## HISTORIC AND DESIGN REVIEW COMMISSION

February 15, 2017

**HDRC CASE NO:** 2017-051  
**ADDRESS:** 2201 W KINGS HWY  
**LEGAL DESCRIPTION:** NCB 6823 BLK LOT 15 AT 2201 W KINGS HWY  
**ZONING:** R-6,H  
**CITY COUNCIL DIST.:** 7  
**DISTRICT:** Monticello Park Historic District  
**APPLICANT:** Joni Harvey  
**OWNER:** Joni Harvey  
**TYPE OF WORK:** Window replacement  
**REQUEST:**

The applicant is requesting a Certificate of Appropriateness for approval to remove existing historic wood bay window and replace in-kind.

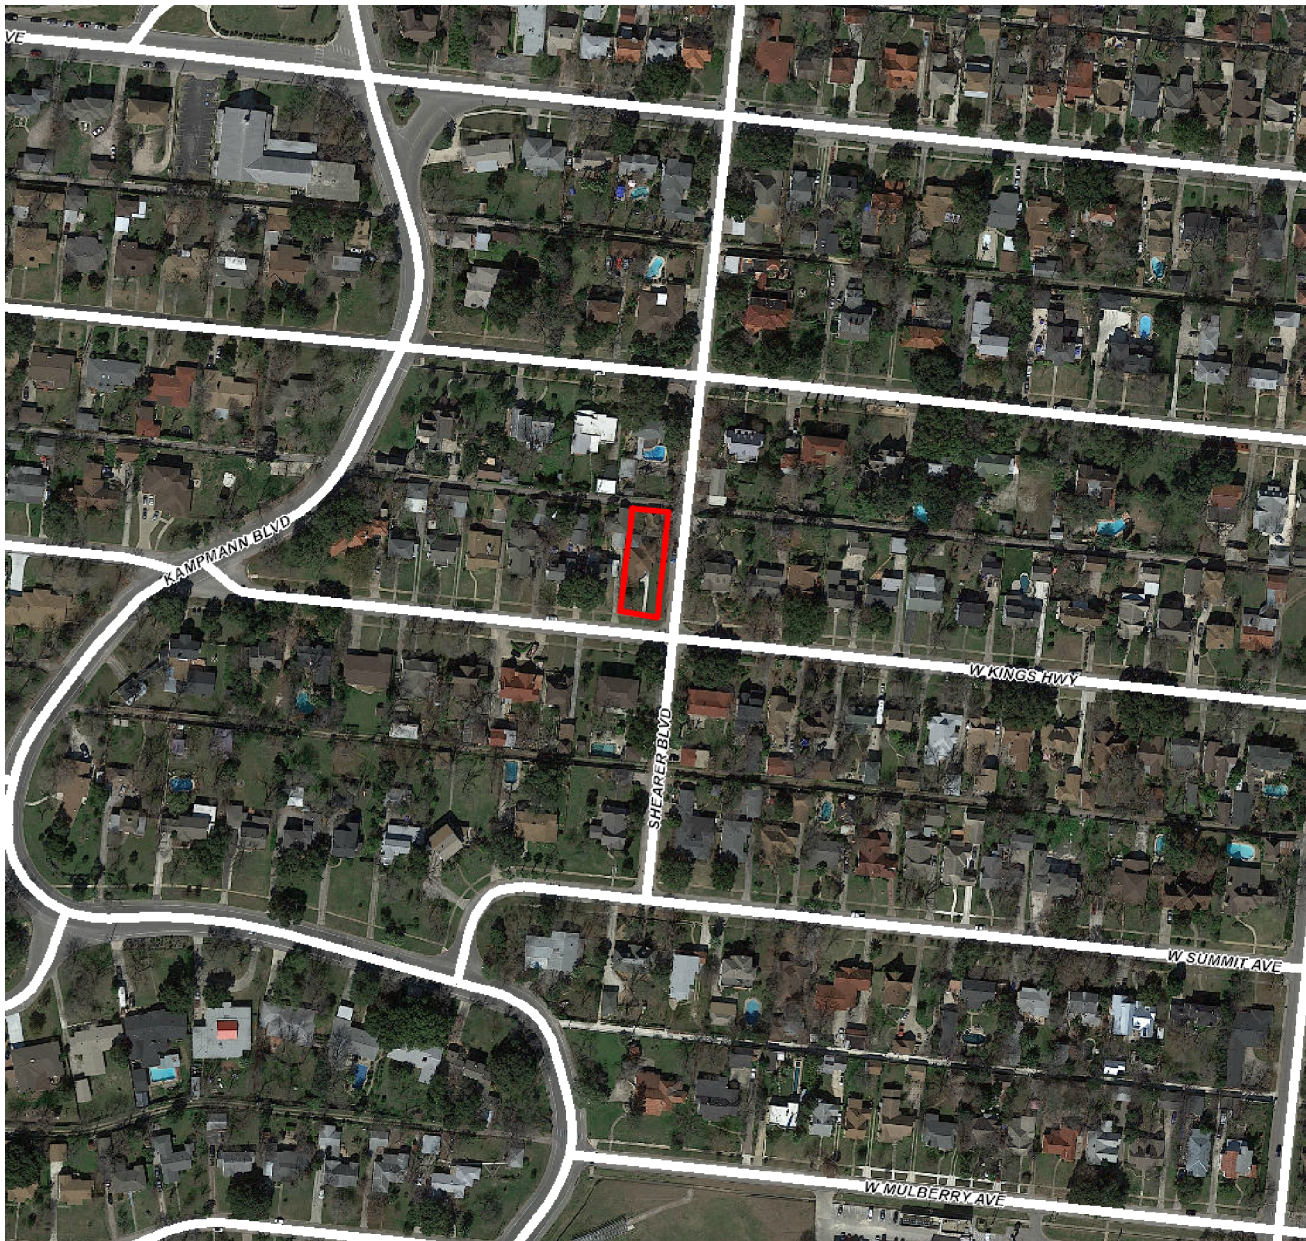
- a. The main structure is a minimal traditional home featuring a stone façade and a composition shingle roof with a front gable and parapet over the front entrance. It is a contributing structure in the Monticello Park Historic District which was designated in 1997.
- b. The existing wood bay window features three 2 by 8 wood casement windows, with three 2 by 2 fixed windows above. The proposed replacement window will match the window in-kind. According to the Guidelines for Exterior Maintenance and Alterations, install new windows to match the historic or existing windows in terms of size, type, configuration, material, form, appearance, and detail when original windows are deteriorated beyond repair. Staff finds the existing right window sash is deteriorated significantly. Staff finds replacement appropriate

for some elements.

Staff recommends approval based on findings a and b with the following stipulations:

1. Repair and reuse window elements as much as possible.
2. Maintain the dimension, profile, and configuration of the originals
3. Feature clear glass
4. Maintain the original appearance of window trim and sill
5. Be inset at least two inches
6. Submit a window detail to staff prior to receiving a Certificate of Appropriateness
